Delegated Report

Application No:	20250258
Location:	Dering Industrial Park, Dering Way, Gravesend, Kent,
Description:	Application for variation of condition 2 attached to planning permission reference number 20160114 for change of use of land to Use Class B8 Storage and Distribution together with formation of new access road; to allow for changes to the scale and siting of the approved B8 use class Plots (A, B, C, D and E) informed by the current layouts of occupied Plots A and B, Re-siting the approved shared central roadway via the existing security gate adjacent to Plot B, the central roadway would now be shared solely by Plots B, C, D and E with Plot A retaining independent gated access from the approved access road, as built and some changes to the siting of installations within each plot (e.g. septic tank, refuse points, noticeboards) to better suit the proposed layout and some changes to the siting of slot drains and storm water attenuation sites to better suit the proposed layout.

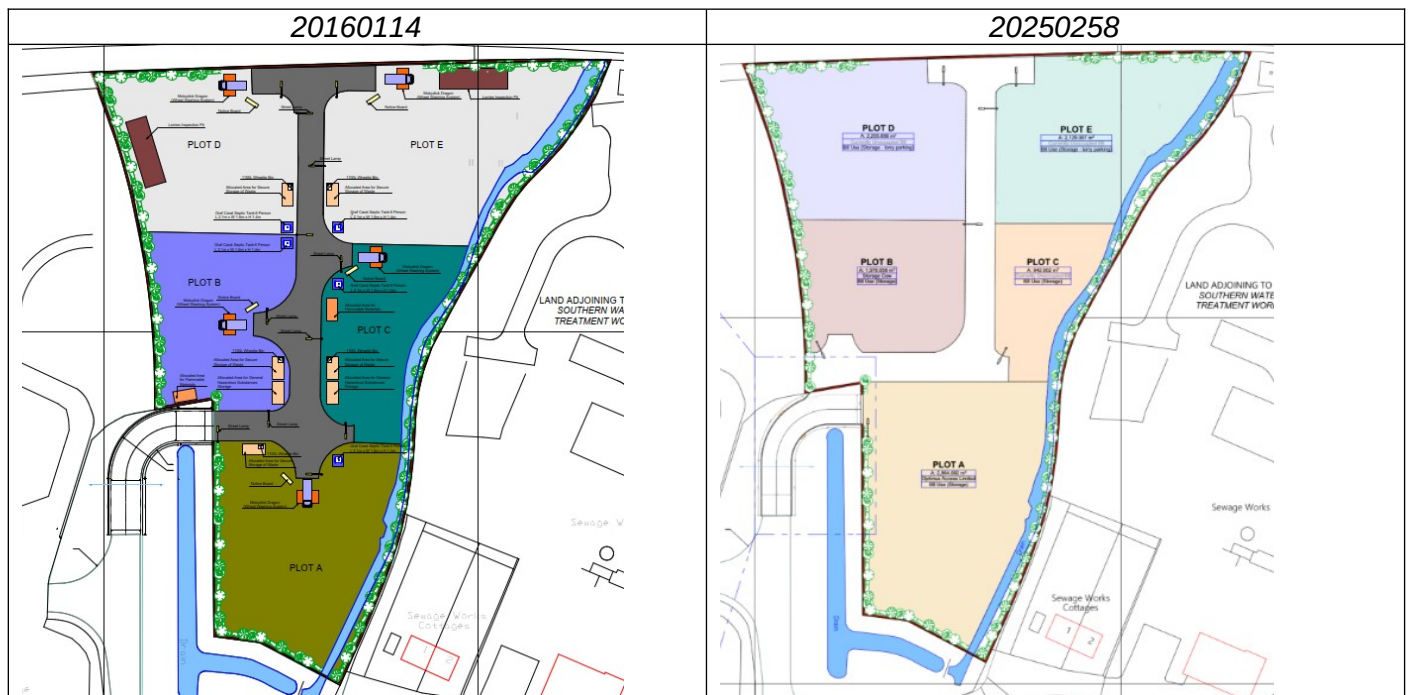
This application seeks to amend the scale and siting of the approved B8 use plots. The size of each plot is subject to change, albeit some greater than others. The changes to the scale of the plots, access road and overall site layout are shown in the comparative screenshots below:

As shown in the images above, the plots have been altered as follows:

- Plot A being increased in size (approx. 692.78m²)
- Plot B being reduced in size (approx. 34.12m²)
- Plot C being reduced in size (approx. 423.9m²)
- Plot D being increased in size (approx. 300.5m²)
- Plot E being reduced in size (approx. 334.25m²)

It is considered that the changes to the plots would have a negligible impact on the character of the site. The industrial character would be unchanged and these changes are therefore considered acceptable.

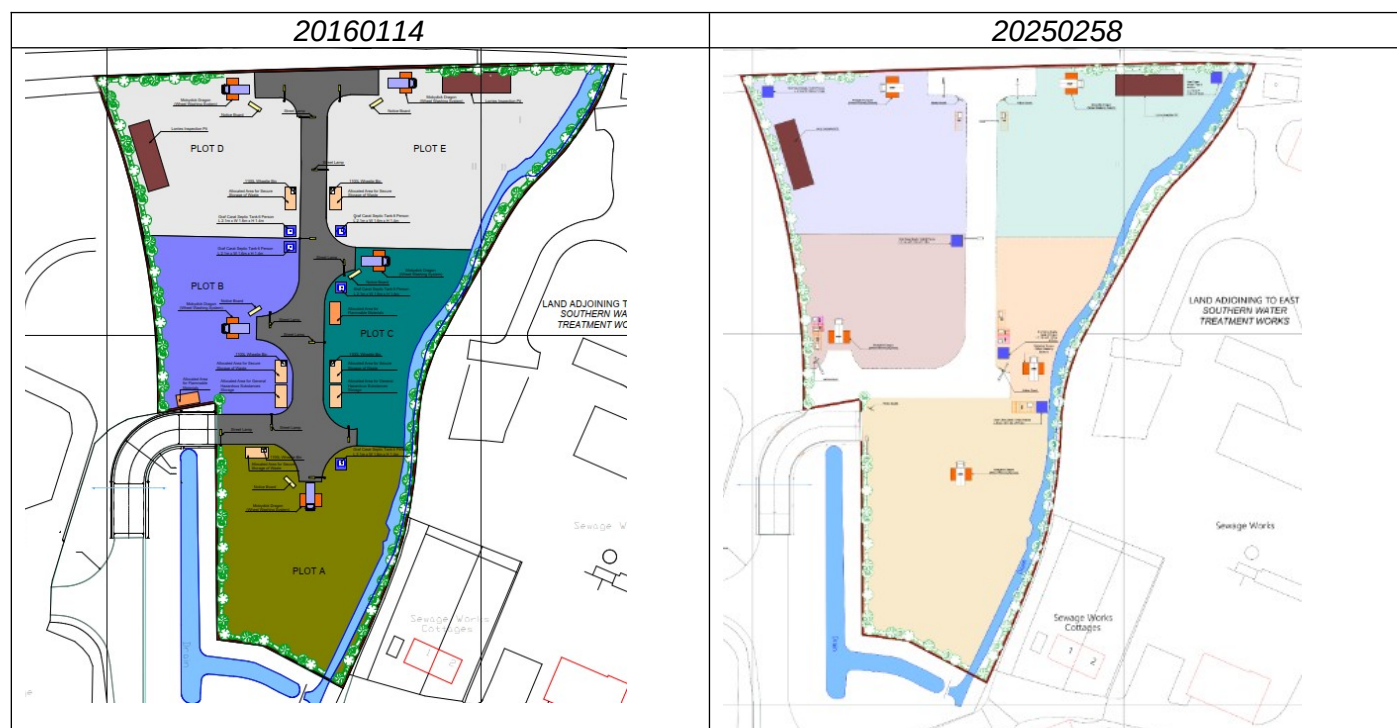
Within each of the plots, the location of the proposed installations have been altered based on the new site layout. The installations relate to waste storage areas, wheel washing facilities, septic tanks, notice boards and lighting columns. Furthermore, the slot drain locations have been updated in response to the changes to the site layout. The changes to the location of the installations is shown in the images below.

The total number of installations within the site would be unchanged, given size and the nature of the installations their resisting would not harm the character of the site and would be in keeping with industrial nature of the site and its surroundings.

20160114	20250258
----------	----------

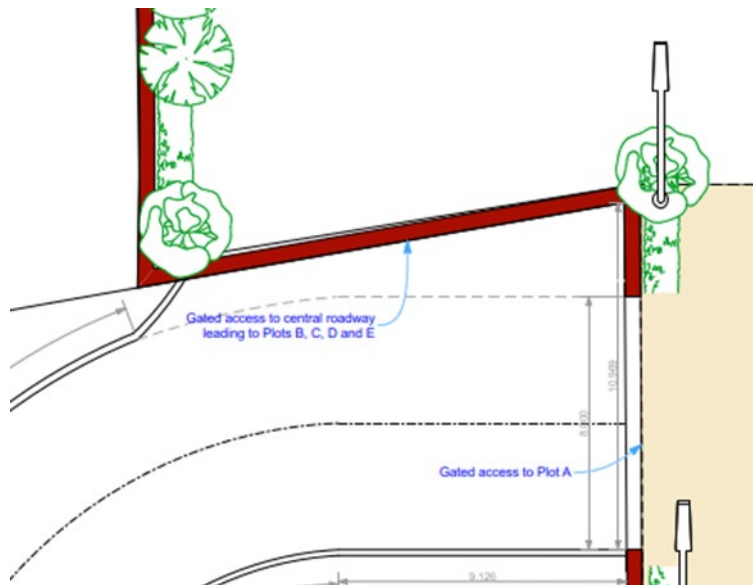
This application seeks to amend the access previously approved shared central roadway. The revised layout would re-site the central roadway via the existing security gate adjacent to Plot B, with the main roadway shared by Plots B, C, D and E. Plot A would retain its existing independent gated access.

The changes to the access are shown in the comparative screenshots below:

The access to the shared roadway is to the north of the originally approved permission, and would run adjacent to Plot B as shown in the image below:

Kent County Council Highways have reviewed the proposal and raise no objection in highway terms. The proposed shared access road has the same width as the previous approval and therefore manoeuvrability is not compromised.

Overall, the re-sited access roadway is considered acceptable in accordance with local and national highway policy.
